Woolworths

74 Edinburg Road,
Marrickville NSW -
Warehouse Facility

**Access Review -
Draft**

14th August 2020

Drawing Title:
Site Plan

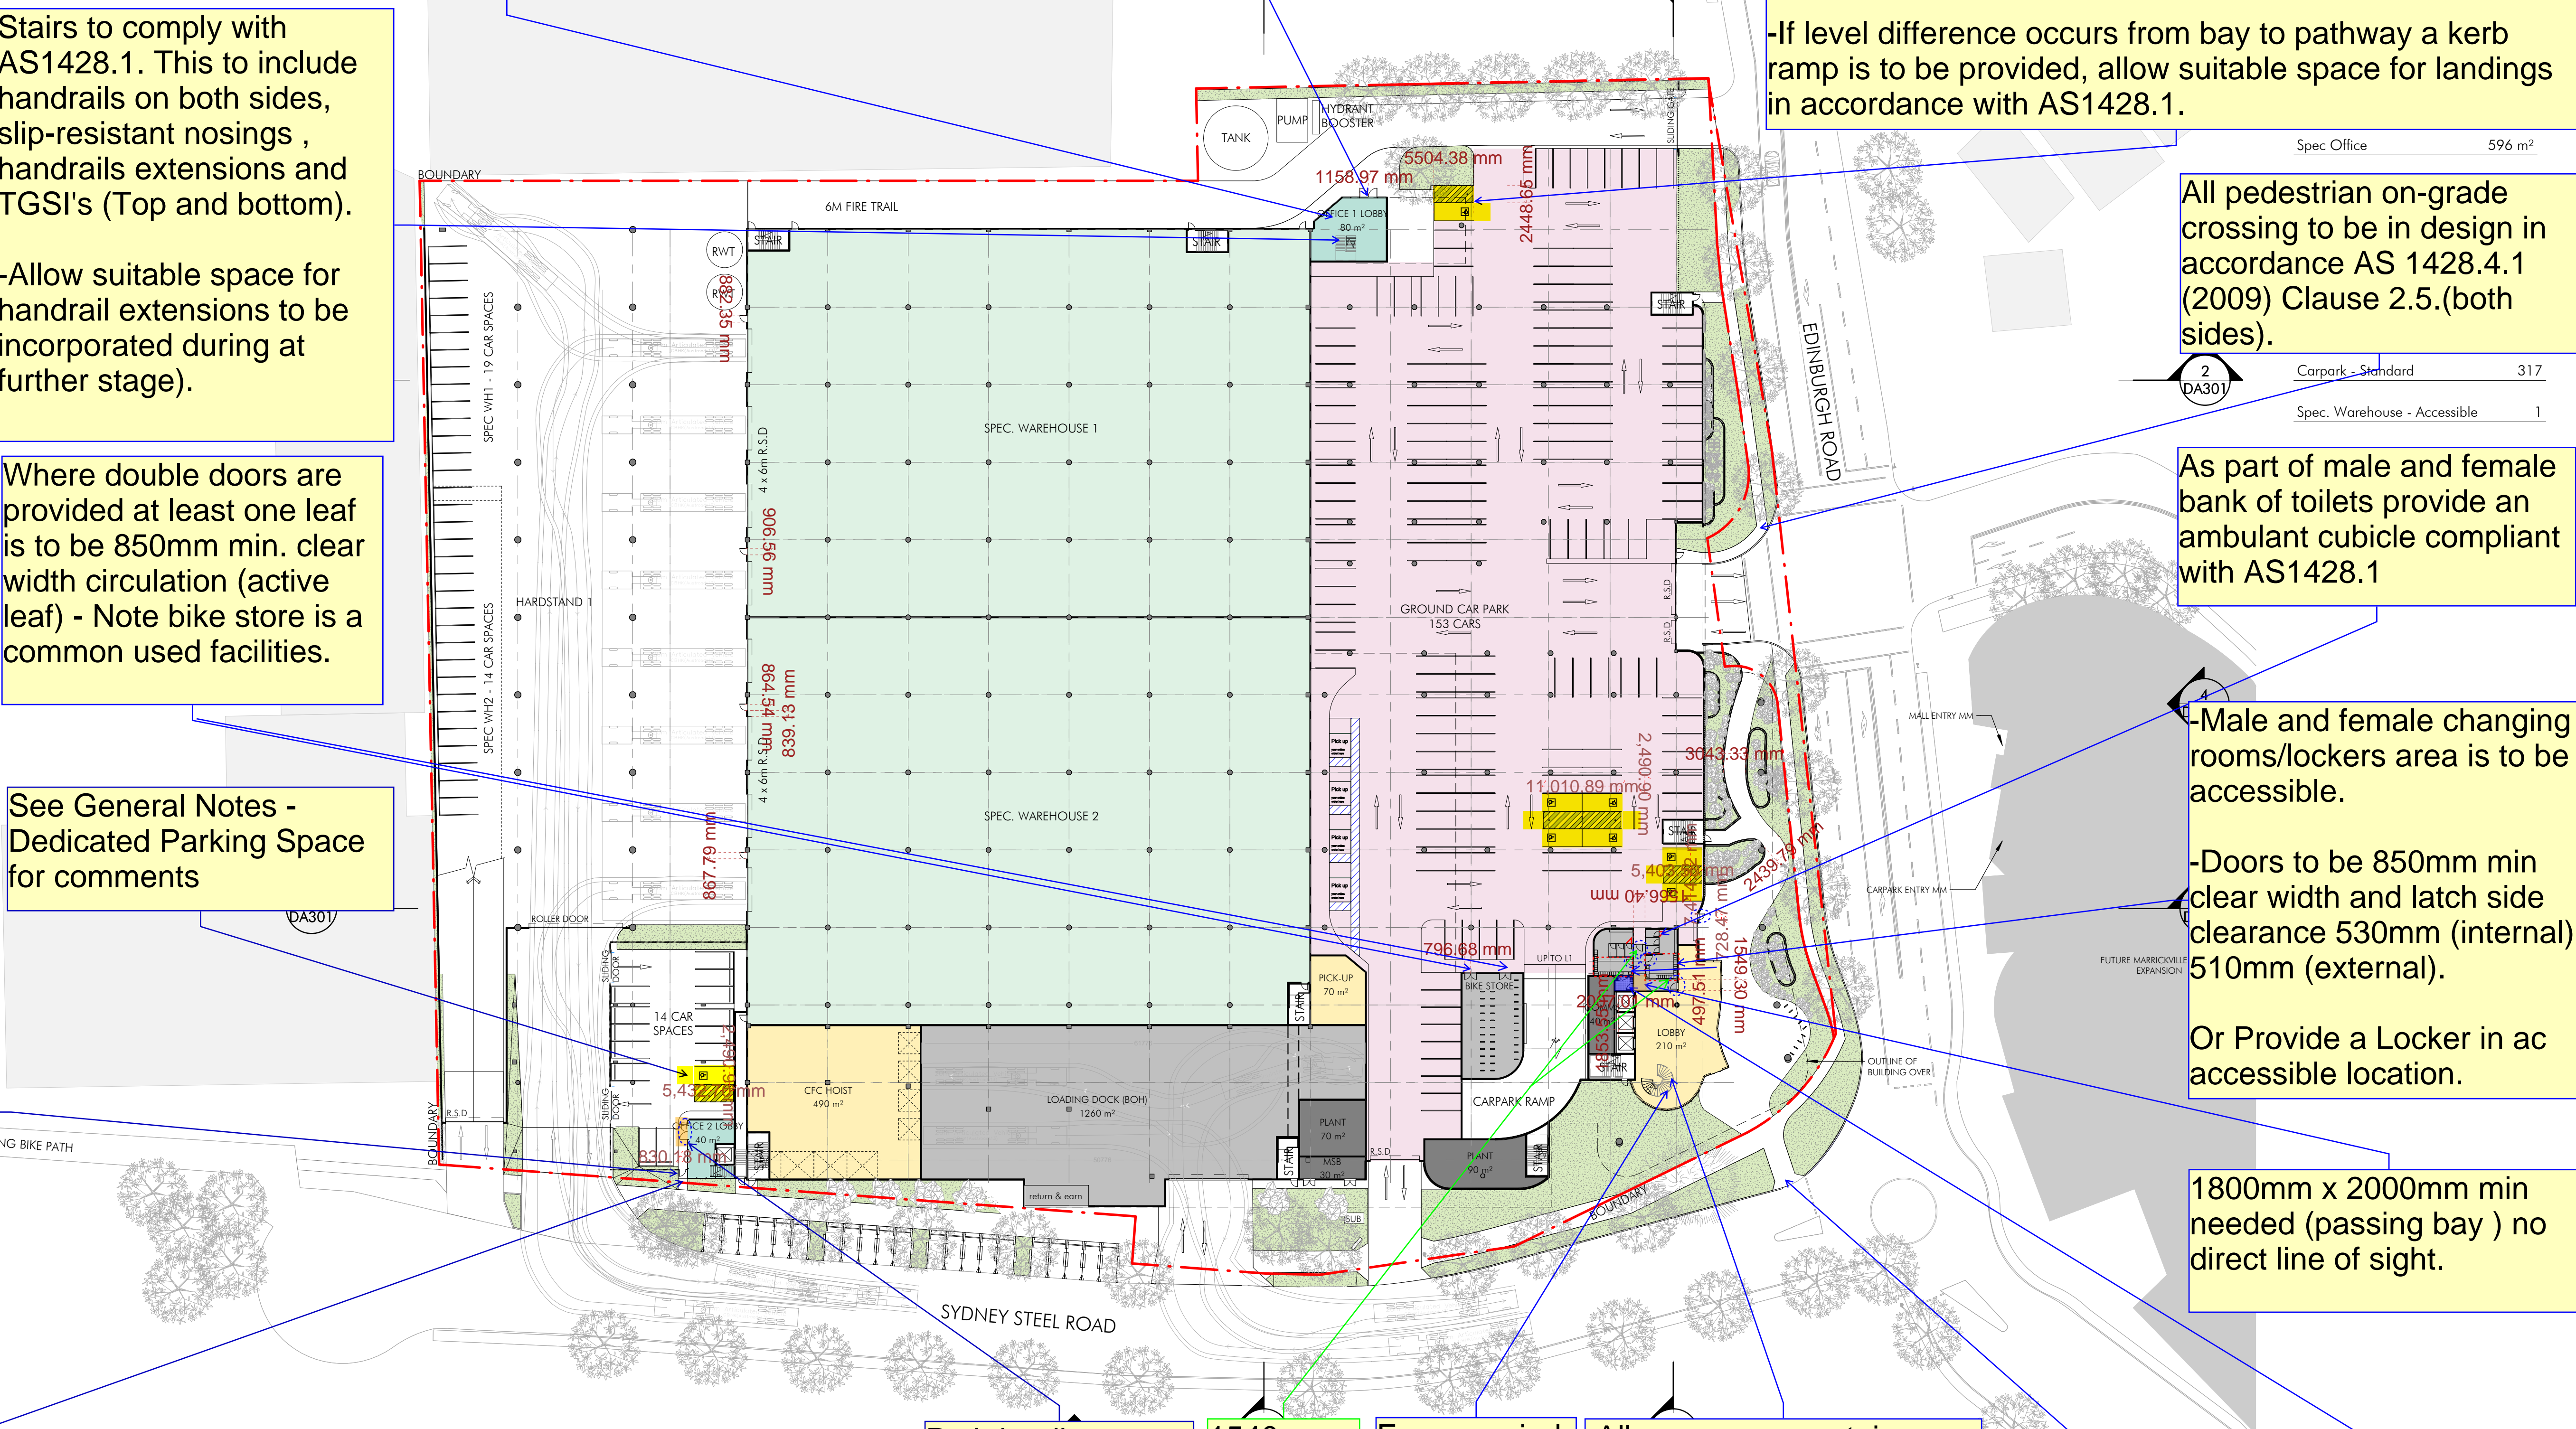
- All commonly use (staff/visitors) doors are to provide 850mm min. clear width.

-Entry Door/gate is to provide 530mm(internal) latch side clearance and 510mm (external) latch side clearance in accordance with AS1428.1, Fig.(g).

Path leading to Office 2 Lobby is to be widened. The double doors are to provide circulation clearances, this to include 1670mm min. L in front and 660mm hinge side clearance. Ensure smooth level transition are provided in accordance with AS1428.1 Cl.7

-Access is not provided from ground to first floor. (DDA Issue) - Access is required to all office spaces

MGAC is to support compliance under **Performance Based Solution**.
(PCA/Planner Consultant require for comment).

Stairs to comply with AS1428.1. This to include handrails on both sides, slip-resistant nosings , handrails extensions and TGSI's (Top and bottom).

- Allow suitable space for handrail extensions to be incorporated during at further stage).

Where double doors are provided at least one leaf is to be 850mm min. clear width circulation (active leaf) - Note bike store is a common used facilities.

See General Notes -
Dedicated Parking Space
for comments

Level transition
required

All pedestrian on-grade crossing to be in design in accordance AS 1428.4.1 (2009) Clause 2.5.(both sides).

As part of male and female bank of toilets provide an ambulant cubicle compliant with AS1428.1

- Male and female changing rooms/lockers area is to be accessible.

- Doors to be 850mm min clear width and latch side clearance 530mm (internal) 510mm (external).

Or Provide a Locker in accessible location.

1800mm x 2000mm min
needed (passing bay) no
direct line of sight.

Path leading to Office 2 Lobby is to be widened. The double doors are to provide circulation clearances, this to include 1670mm min. L in front and 660mm hinge side clearance.

1540mm x
2070mm
min. end
of
corridors
circulation
space
needed

37 DA101

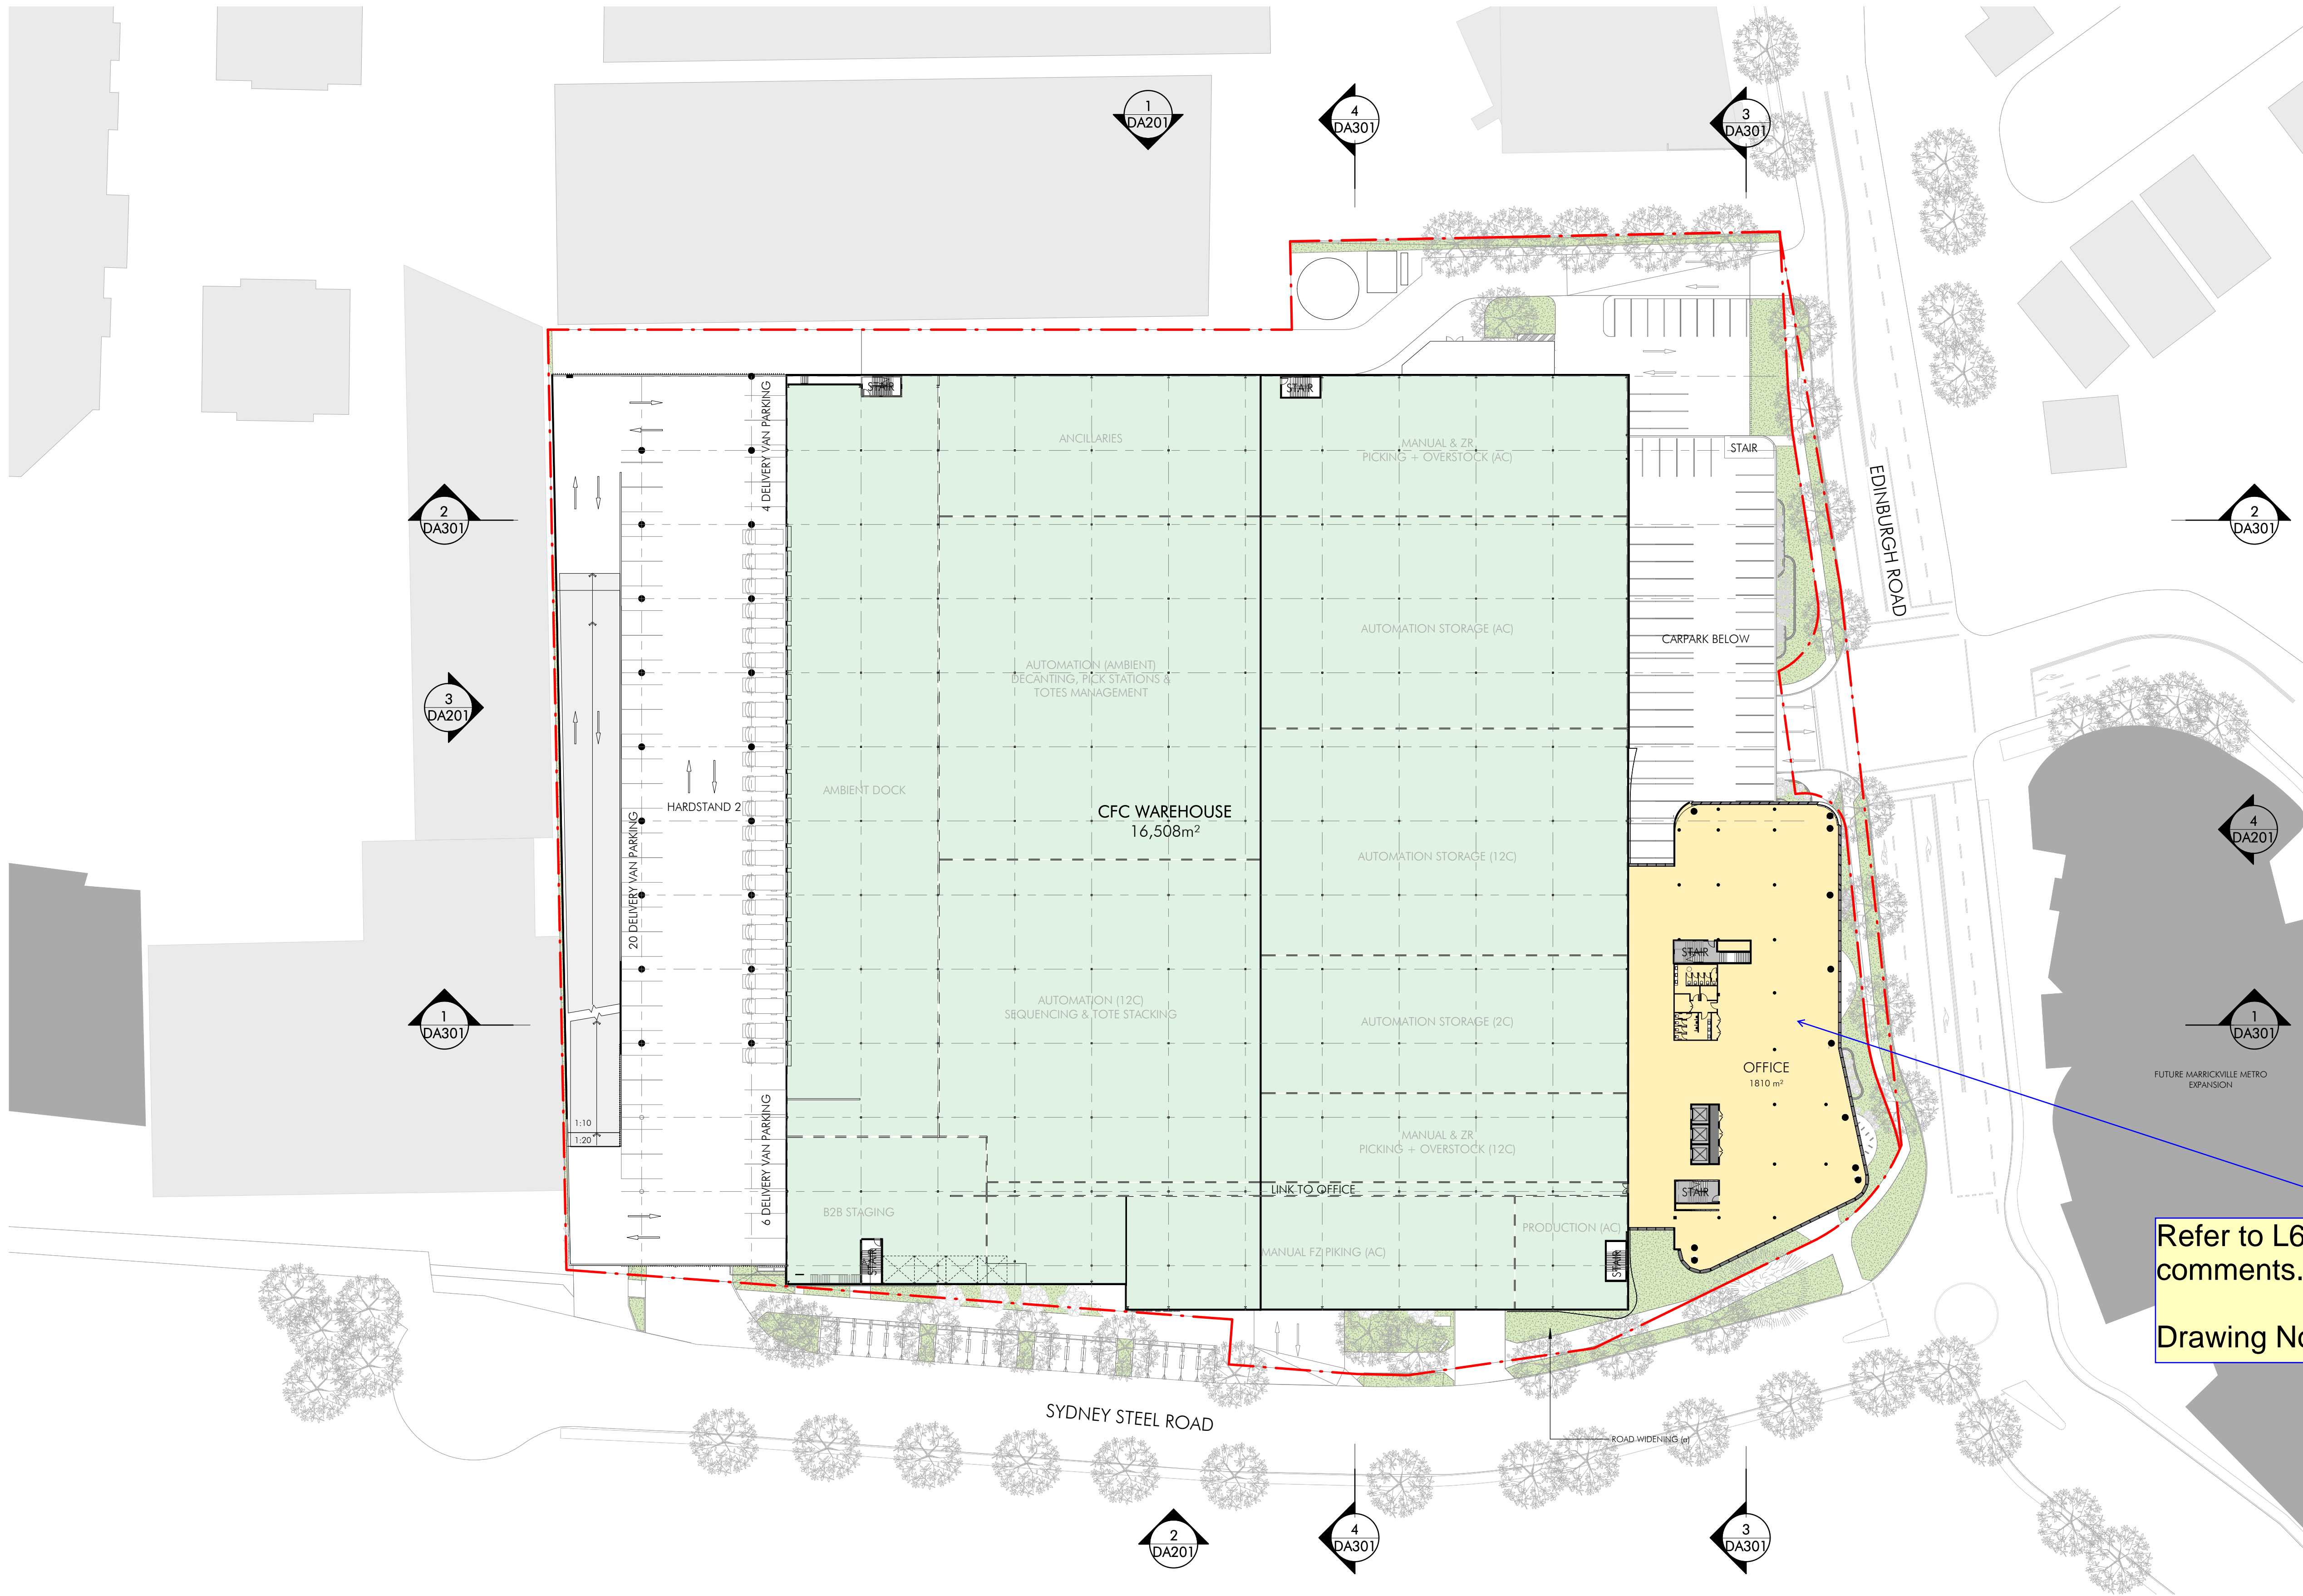
Ensure spiral stairs the going provides 250mm min. at the narrowest side in accordance with BCA table D2.13.

- All common use stairs (staff and visitors) to comply with AS1428.1. This to include handrails on both sides, slip-resistant nosings, handrails extensions and TGSI's (Top and bottom).
- Allow suitable space for handrail extensions to be incorporated during at further stage).

All site kerb ramps are to be compliant with AS1428.1.

b -1900mm x 2300mm min.
clear circulation around the
pan needed, excluding basin
(Note: basin is 430mm min.
projection) with AS1428.1
Fig. 52.

-Currently basing encroachment into pan circulation is 330mm.
